Southern Utah Wilderness Alliance
Petition for Review
UIC Permit UT22291-10328

**DECLARATION OF BRIANA E. MORDICK (filed in support of)
PETITION FOR REVIEW**

Re: Comments - Draft Permit, EPA UIC Permit UT22291-10328, River Bend Unit 1-10D Well

Subject: Comments on Draft Underground Injection Control Permit UT22291-10328, Class II Enhanced Oil Recovery Well, RBU 1-10D, API No.: 43-047-34312, Uintah County, UT

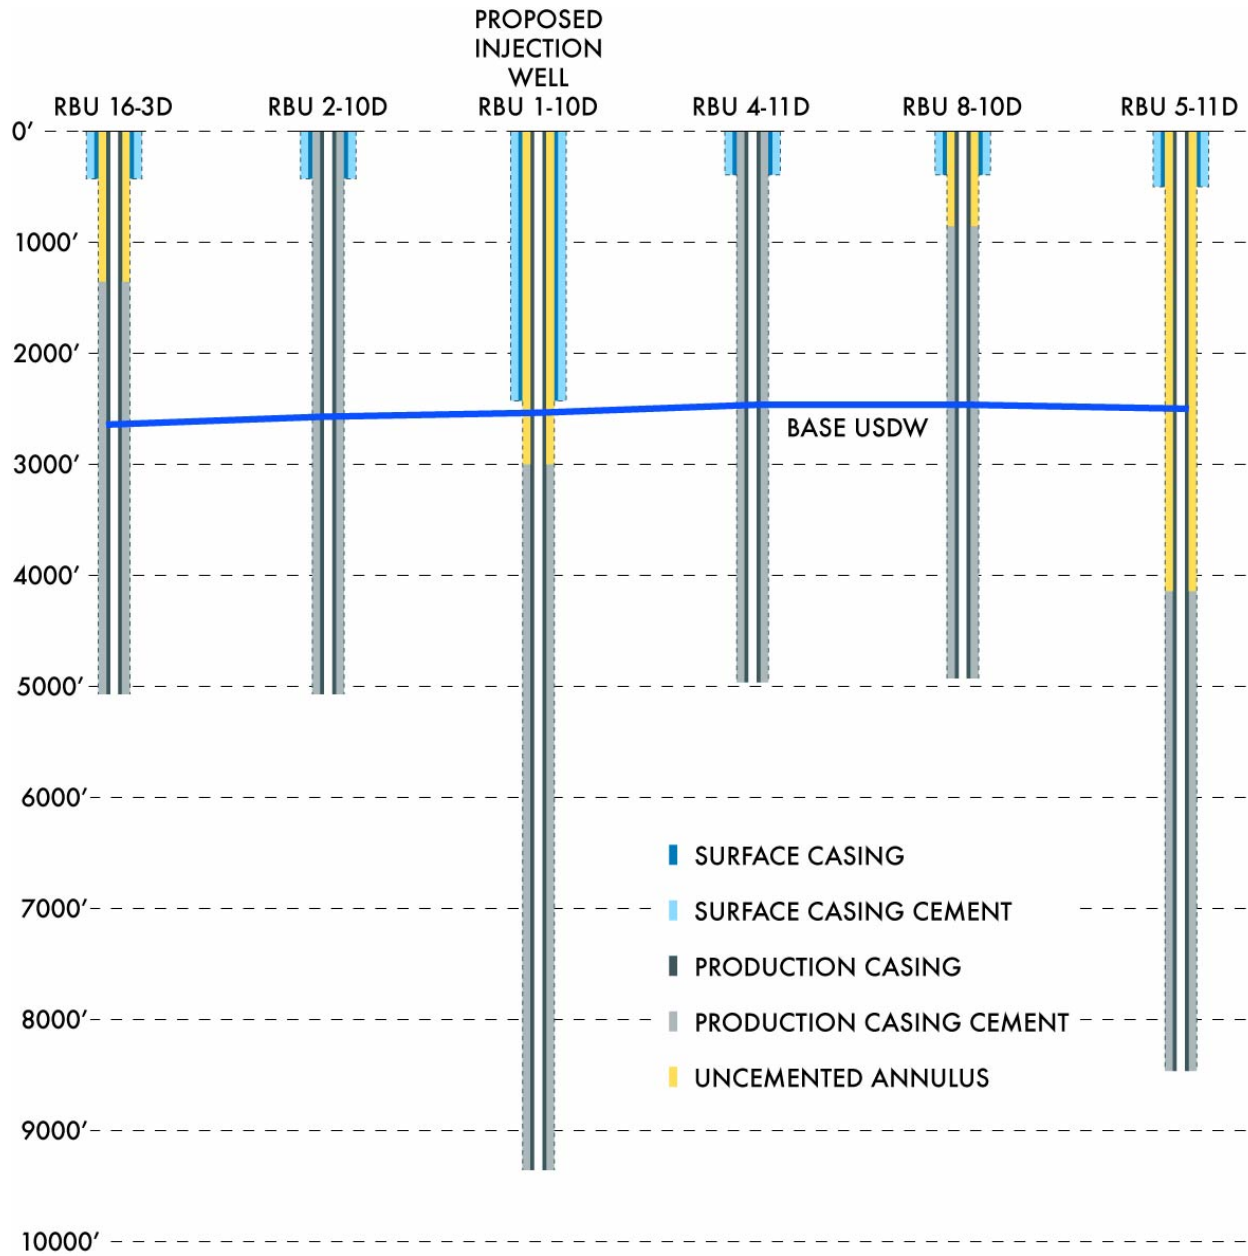
In the permit application, the base of the deepest USDW in the proposed injection well is estimated at 2523 feet. However, the surface casing, which is intended to isolate and protect usable groundwater, is set at 2414 feet. Furthermore, the top of cement behind the production casing is estimated to be at 2980 feet. In other words, the surface casing does not extend below the base of the USDW and the production casing cement does not extend above the base of either the USDW or the surface casing. This means that a portion of the annular space adjacent to the USDW is uncemented. Leaving this annular space uncemented puts both the USDW and well integrity at risk.

The surface casings for the wells identified in the permit application as being within or near the ¼-mile AoR are set significantly shallower than the surface casing in the proposed injection well. The permit application does not specify the depths to the base of the USDW for these wells. However, a review of the map of the Base of Moderately Saline Ground Water ("BMSW")², which, as stated in the draft permit, "corresponds to the base of the USDWs in the area," indicates that the BMSW in these offset wells is likely to be at similar depths as the BMSW in the RBU 1-10D, or approximately 2500 feet. The surface casing in all five listed offset wells does not extend below the base of the USDW.

As with the RBU 1-10D, in three of the five offset wells, the top of the production casing cement does not extend above the base of the surface casing. In one such well, the RBU 5-11D, the top of the production cement also does not extend above the base of the USDW. In this well, the base of the surface casing is at 500', the base of the USDW is at approximately 2500', and the top of the production casing cement is at 4160', meaning that almost 1650 feet of wellbore behind the production casing is uncemented.

Failing to extend surface casing in any well to below the base of the lowest USDW puts those USDWs below the base of the surface casing at significant risk of contamination. Cross flow may occur between the USDW and other formations, potentially leading to contamination of the USDW. Leaving a potential flow zone uncemented can also result in overpressurization of the annulus and/or result in casing corrosion, both of which may lead to a well integrity failure, further putting drinking water at risk. Properly constructed wells typically have at least two barriers between USDWs and fluids contained in the well: 1) the surface casing and 2) the
